BEFORE THE HEARING EXAMINER
FOR THE CITY OF REDMOND

**DECLARATION OF RICK
DRIFTMIER, AIA**

Review of Drawings labeled as: "Origin's Tenant Improvement and Change of Use" and signed by Thomas G. Morris of Morris Architects, Inc. PS dated 12-05-16, revised 1-20-17 and approved by the City of Redmond 1-25-17.

Review by The Driftmier Architects, PS on 4-28-17

FIG. 404.2.3.2
MANEUVERING CLEARANCE AT MANUAL SWINGING DOORS

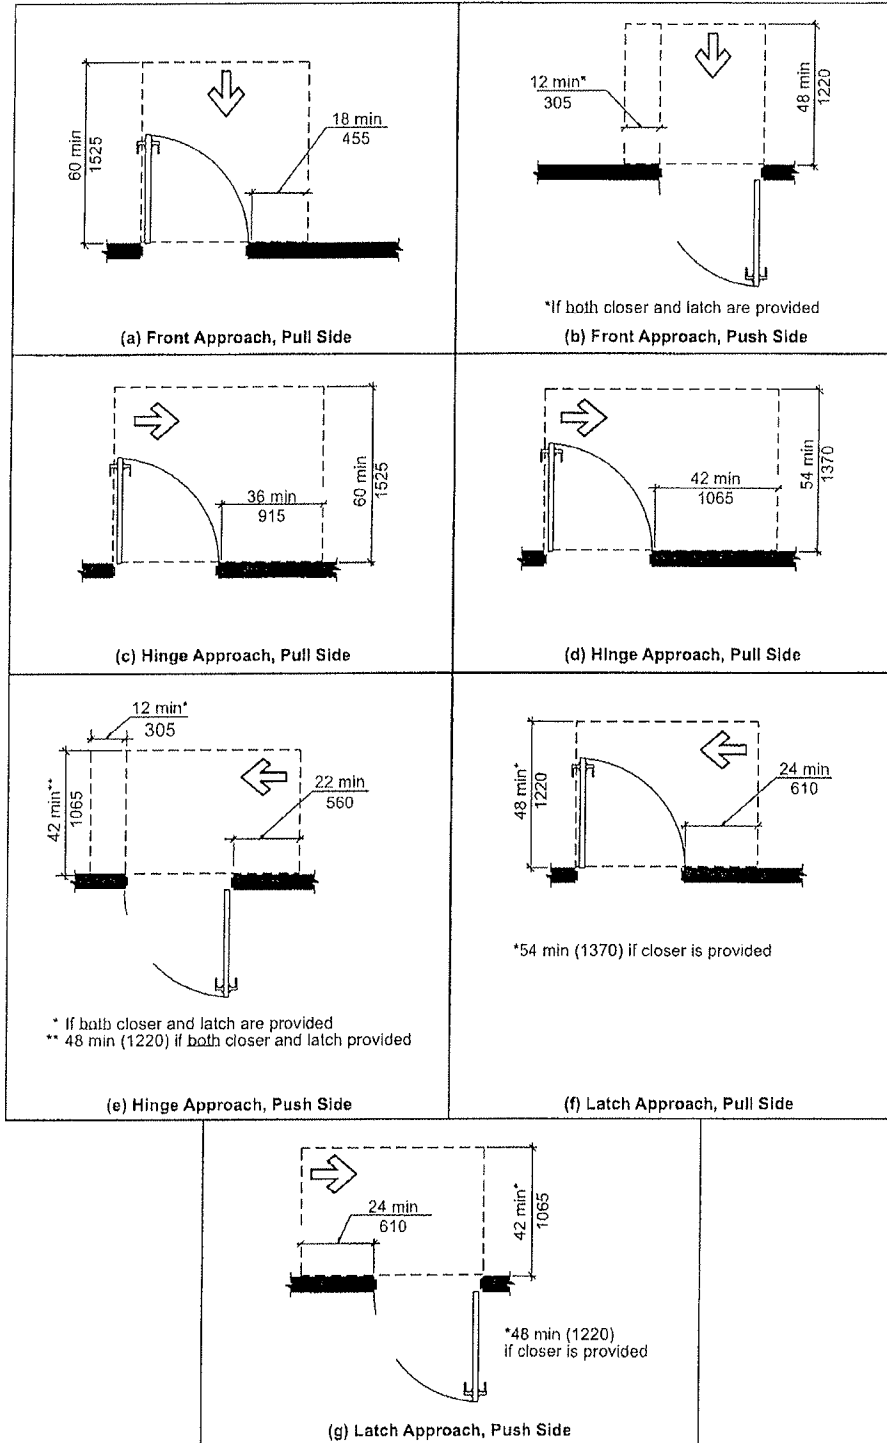
- The shelving in the storage room does not allow for ADA clearances around the door. The attached sheet shows the different clearances required depending on the approach direction to doors. The shelves are within the clearances for all of the optional approaches.
